TO: Prospective Bidders
CC:
FROM: Southeastern Regional Transit Authority (SRTA)
DATE: 12/11/2020
RE: Responses to Questions and Clarifications (SRTA RFP 21-02) Addendum #1

SRTA Request for Proposals (RFP 21-02) for Driver Protective and Safety Barriers

Addendum #1

- Floor to ceiling of the driver/operator area (Gillig 30')

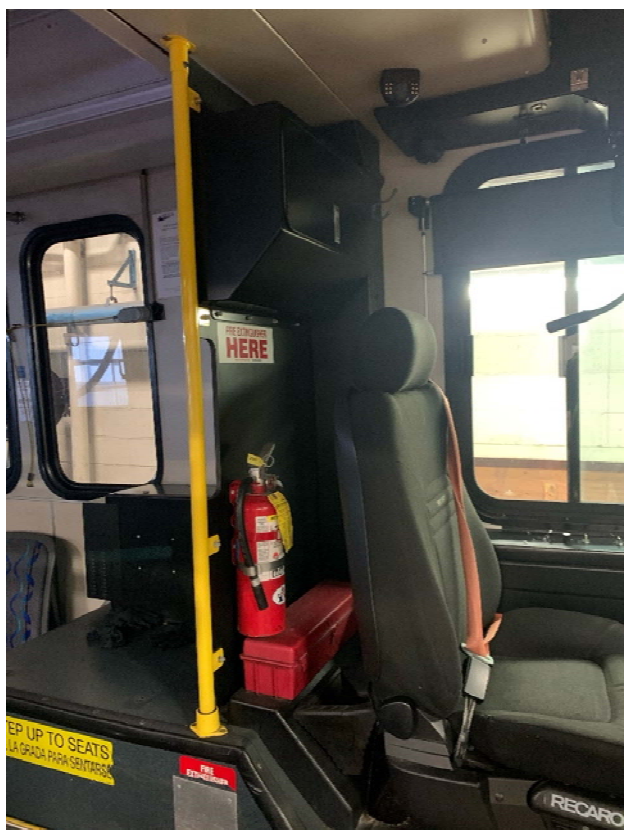
- Zoomed out picture showing floor to ceiling of the driver's/operator area
- Front and Side view of the Stanchion/Farebox
- Front and Side view of Pedestal
- Curb side wheel well

Gillig 30' Model, as followed:

OPERATOR AREA

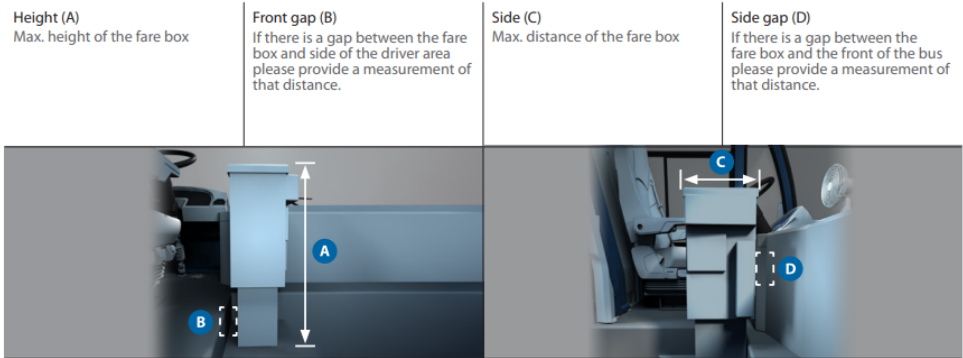
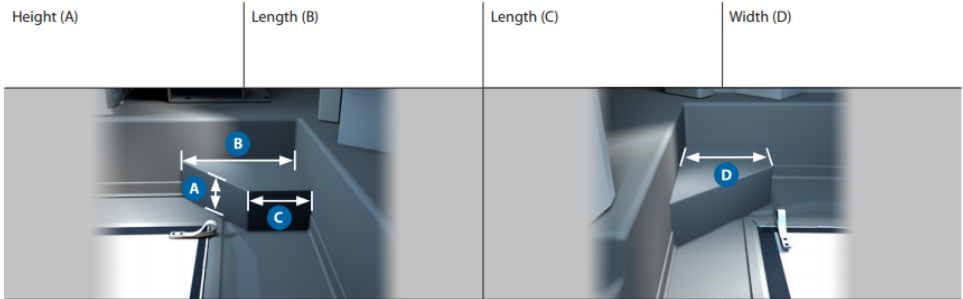
- Please also provide dimensions for Gillig 30' models.

Side (A): 41 ¼”

Side (B): 2”

Side (C): 10 ¼”

Side (D): 5 ¼”

Pedestal (A): 6 ¼”

Pedestal (B): 26 ¾”

Pedestal (C): 13”

Pedestal (D): 14 5/8”

- Floor to ceiling of the driver/operator area (Gillig 35')

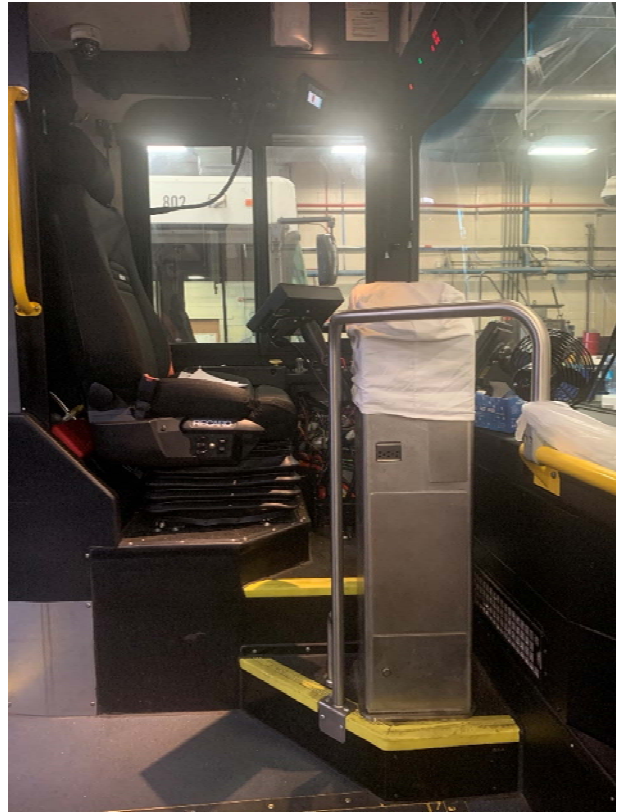
- Zoomed out picture showing floor to ceiling of the driver’s/operator area
- Front and Side view of the Stanchion/Farebox
- Front and Side view of Pedestal
- Curb side wheel well

Gillig 35' Model, as followed:
